COMPON	ENT CODE 87
PARTS & SERVICE	REF NO.	AT97252
NEWS	DATE	Nov. 17, 1997
	(C)	Page 1 of 4

- SUBJECT: IMPROVED FUSE BROKEN OF AIR CONDITIONER BLOWER MOTOR ON DUMP TRUCK
- **PURPOSE:** To introduce modification procedures to prevent fusion of the fuse for the blower motor of the air conditioner on dump trucks of the models listed below.
- APPLICATION: HD325-6 Dump Trucks HD405-6 Dump Trucks HD465-5 Dump Trucks HD605-5 Dump Trucks HD785-3 Dump Trucks HD985-3 Dump Trucks

Fuse Box III

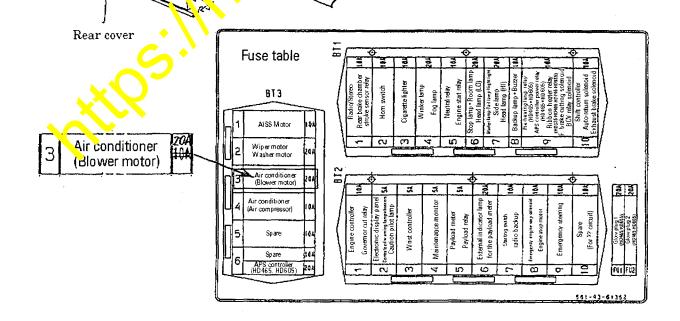
- 3. Replacing the fuse for the blower motor of the air conditioner and changing the nameplate
 - 1) Replace the fuse (Fuse No. 23 in the fuse box III) for the blower motor of the air conditioner ($10A \rightarrow 20A (08041-02000)$).

2) Open the cover located at rear of the operato.'s seat and correct the fuse capacity for the blower motor for the air conditioner on the fuse layout label being applied on the inner surface of the cover to "20A".

No.	Fuse capacities	Circuit names
23	10A	AISS motor (HD785-3 & HD985-3)
22	20A	Wiper motor, washer motor
▶23	$10A \rightarrow 20A$	Blower motor for the air conditioner
24	10A	Air compressor
25	10A	Spare
26	20A	APS power (HD465-5 & HD605-5)
